ADVISORY NOTIFICATION

Rugby Lamp Wire Harnesses

Att'n: Rugby Sales & Service – All Rugby Customers Receiving 1847743 & 1847744
Release Date: 4/19/2017

Picture A

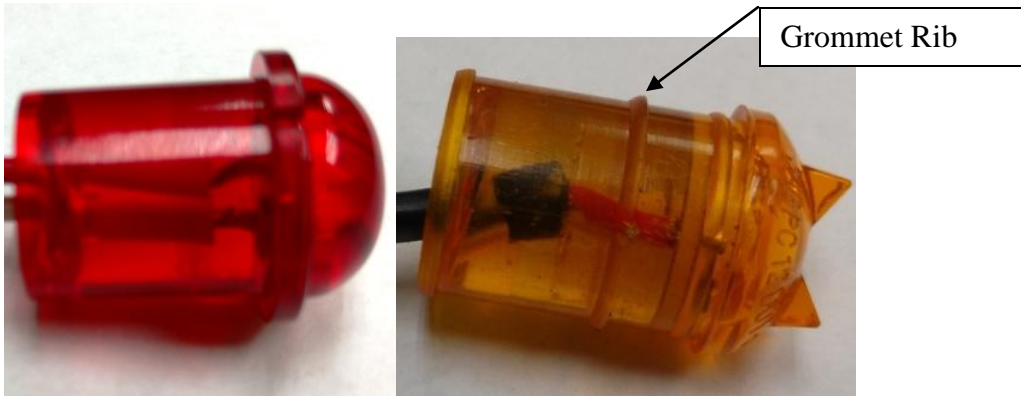
Rugby Mfg has recently learned that due to a Vendor design change, LED lamps PN 1847743 & PN 1847744 may not fit as securely as desired after installation. Picture A shown below does not contain the grommet rib as shown in picture B. Picture B is of the prior version which contains an additional rib to secure the lamp within the grommet. While the lamp pictured in A is functional and may be used, it does not meet the quality expectations of Rugby Mfg. If you have received LED lights as shown in picture A and feel they do not sufficiently secure the lamp, please contact Rugby Mfg customer service to have replacement lamps sent to you. The original lamps will not be required to be returned.
